SUNDRY NOTICES REPORTS ON WELLS (DO NOT USE THIS FORM FOR PROPOSALS TO DRILL OR TO DEEPEN OR PLUG BACK TO A DIFFERENT RESERVOIR. USE "APPLICATION FOR PERMIT" (FORM C-101) FOR SUCH PROPOSALS.)		WELL API NO. 3002526958
1. Type of Well: Oil Well ☐ Gas Well ☐ Other ☒		5. Indicate Type of Lease STATE ☐ FEE ☒
2. Name of Operator: Agave Energy Company		6. State Oil & Gas Lease No. SCR-389
3. Address of Operator 104 S. Fourth St., Artesia NM 88210 (575-748-4528)		7. Lease Name or Unit Agreement Name Sims
4. Well Location Unit Letter _____ K: 1980 feet from the _____ N line and 800 feet from the _____ E line Section 13 Township 24S Range 33E NMPM Lea. County		8. Well Number #1
11. Elevation (Show whether DR, RKB, RT, GR, etc.)		9. OGRID Number 147831
10. Pool name or Wildcat Big Sinks Wolfcamp

NOTICE OF INTENTION TO: PERFORM REMEDIAL WORK ☐ PLUG AND ABANDON ☐ TEMPORARILY ABANDON ☐ CHANGE PLANS ☐ PULL OR ALTER CASING ☐ MULTIPLE COMPL ☐ DOWNHOLE COMMINGLE ☐ OTHER: ☒ Replug to cement off Cherry Canyon per NMOCC R-13507	SUBSEQUENT REPORT OF: WORK ☐ ALTERING CASING ☐ PLUGGING OPNS ☐ P AND A ☐ 24 hours prior to the beginning of plugging operations. OTHER:
--	---

SIMS 001
API # 3002526958
1980'

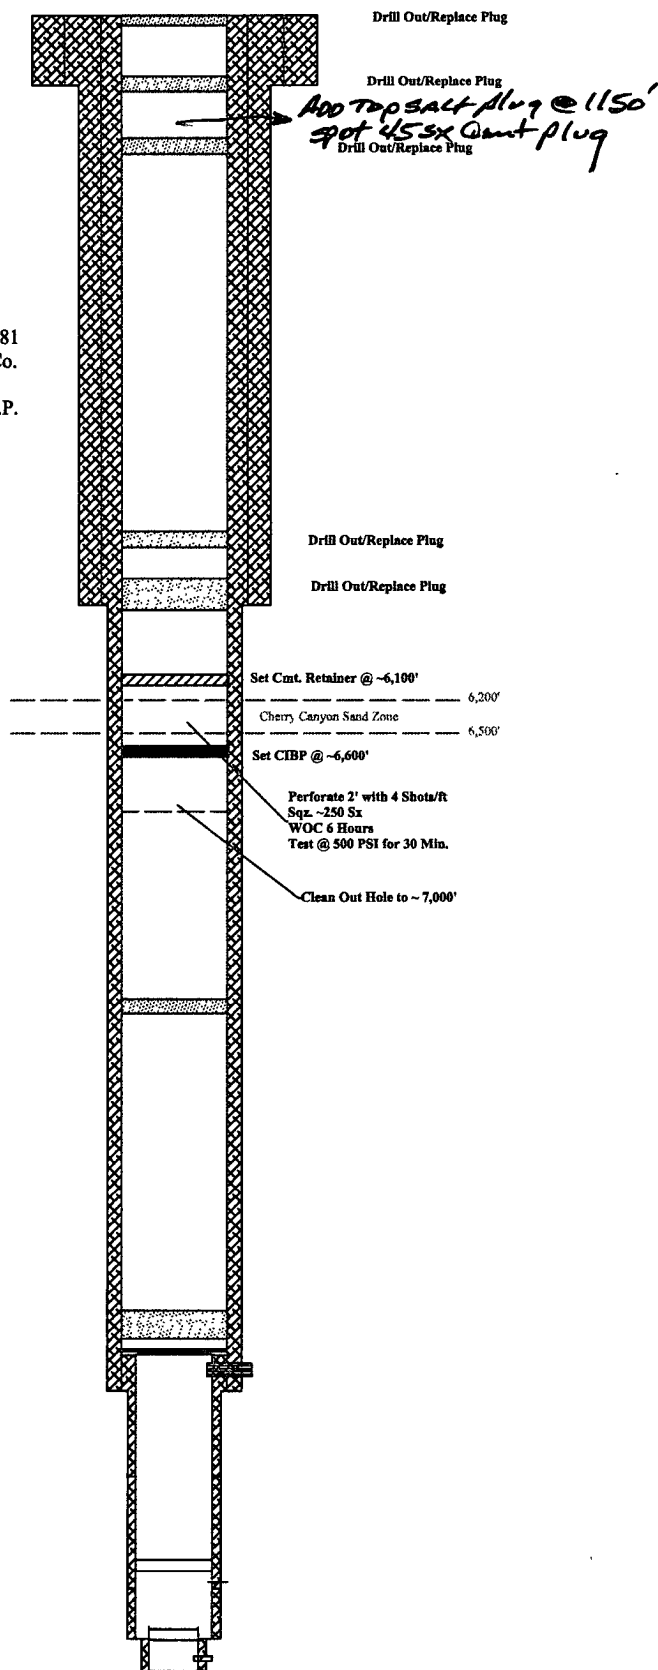
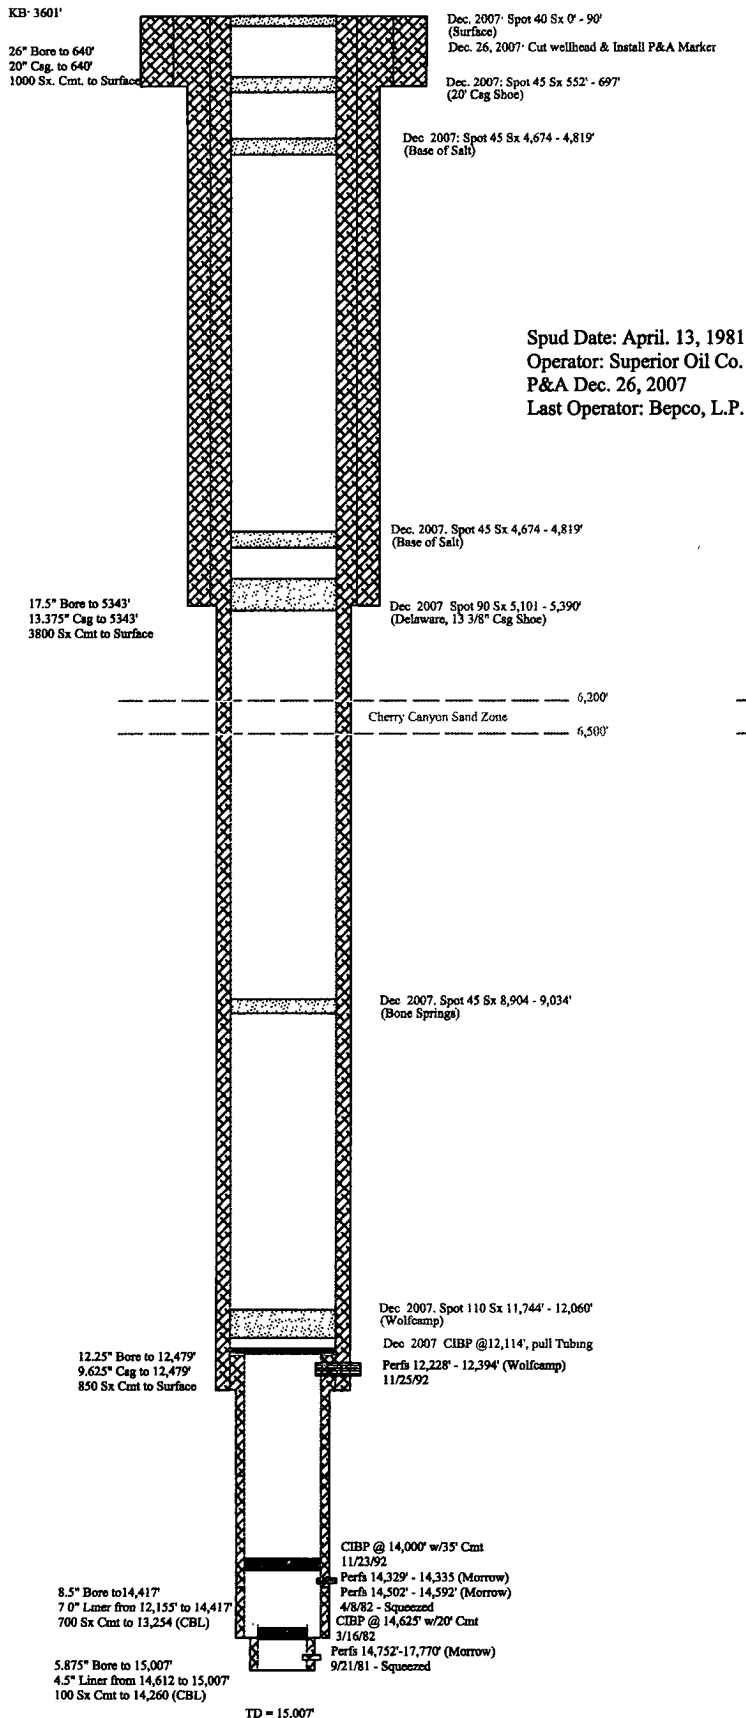
→ ADD Top Sack Plug @ 1150' → Spot 455x cement plug
